*Customer information with safety notices
regarding the restraint systems of the types LE 25 and LE 32*

Annex 1: Paint marking of the piston rod at joint head

Annex 2: Inspection of the Threaded Screw Assembly

Annex 3: Particulate within the hydraulic cylinder

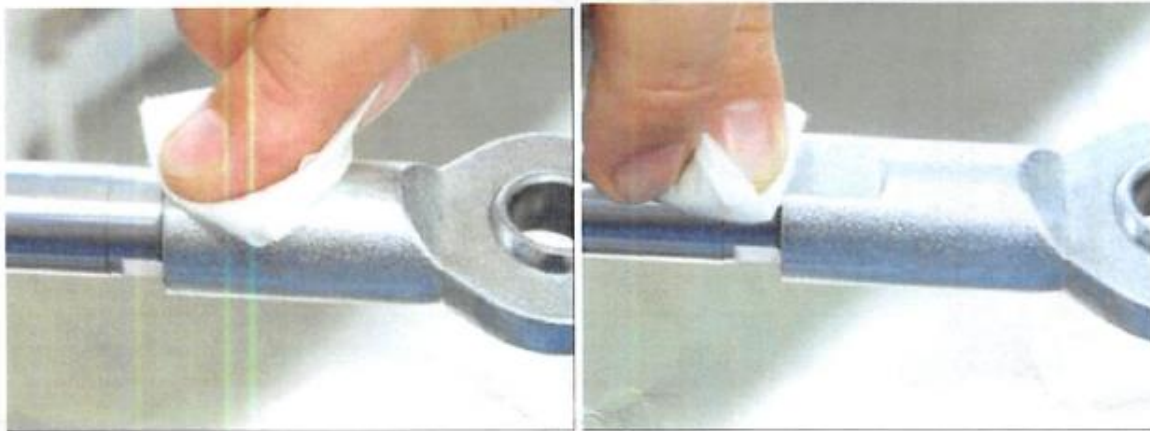
It is possible that a loose joint head connection could lead to a malfunction in the locking mechanism within the Personal Restraint System during a ride. Vibration or improper adjustment of the threaded screw assembly can cause the connection between the rod-side joint head and the piston rod end to loosen during normal use. We are aware of only one instance (not involving personal injury) where this connection came loose under load and we have also observed several cases in the field where joint heads were loose. The simple procedure described below will help reduce risk.

We recommend that the position of each head joint should be checked and the correct position be referenced marked with highly visible paint marking to facilitate a daily inspection. This recommendation should be shared by you with the end user customers.

Step1: Apply paint marking to the joint head

- Use a general purpose parts cleaner and degreaser prior to painting. The area should be free of residue after cleaning. The area to be marked on the joint head and piston rod should also be free of rust. We recommend Loctite® 7063 or DuPont 3608S™ or 3M™ S-151 Cleaner.
- Do not use brake cleaner or a nitro-cellulose combination thinner.
- Be careful not to damage the piston rod itself and keep the cleaning fluid off the section of the piston that moves in and out of the cylinder.

Paint Marking

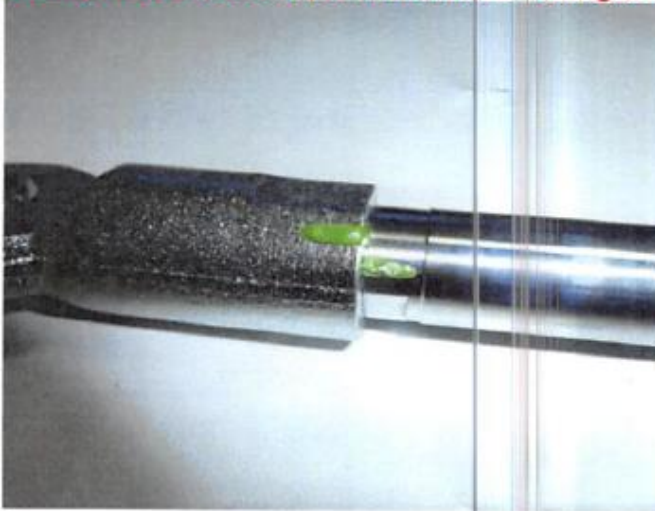
Use a high quality visible thread locking paint and follow the recommended application instructions. After consultation with you, we will determine the quantity of paint required and we will supply it to you. The paint marking should be one continuous line running from the joint head to the piston rod. The paint should be applied at a point where it will be visible to the operator during daily checking.

The correct position of the joint can be verified by checking to see that the paint marking between joint head and piston rod is undamaged.

All units should be inspected daily before use. If the paint marking is discovered broken or if the joint head is not completely screwed in, the unit should not be used because the Personal Restraint System may fail possibly leading to personal injury or death of a rider. It must be exchanged immediately and returned to the manufacturer with a defect description.

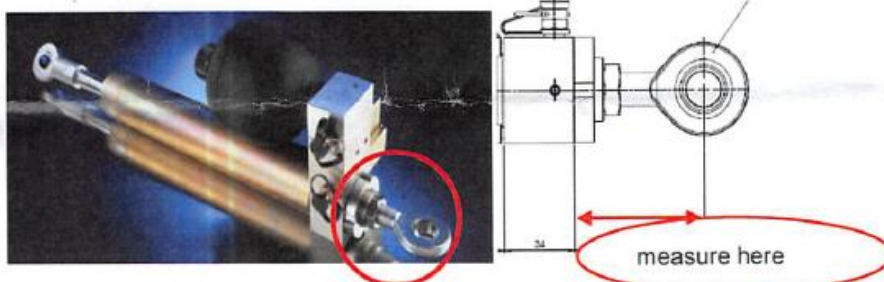
This information is important for anyone performing installation or service on any personal restraint system using our LE assemblies and should be passed on. We have learned that some end users are sometimes unscrewing the threaded screw assembly out too far. This assembly is located on the cylinder base side and is circled in the picture below. Please note that the position of the thread is not intended as an adjustment for the spacing between two points within a personal restraint system. If this assembly is unscrewed too far there will be insufficient screw threads meeting the fitting to provide a secure connection. The result is an unsecure connection which could lead to a malfunction of the locking mechanism in the Personal Restraint System during a ride. This could cause serious injury or death. Always check that screw thread depth is correct. The diagram and photo below shows the measuring points to determine the correct screw thread depth.

The following data apply for all LE 32 versions:

For LE 32 versions the screw thread depth is correct when the rod extends no farther than distance of 64 mm (+/- 1 mm).

We recommend that the joint rod heads be secured at the specified dimensions and tightened with a torque wrench. The LE 25 version should be tightened to **80 Nm ±10 Nm**. The LE 32 version should be tightened to **90 Nm ±10 Nm**.

The correct measurement must be set and checked when installing or performing maintenance on the Cylinder Accumulator unit. In this way the required minimum screw thread depth engagement (as set out in VDI 2230) is maintained.
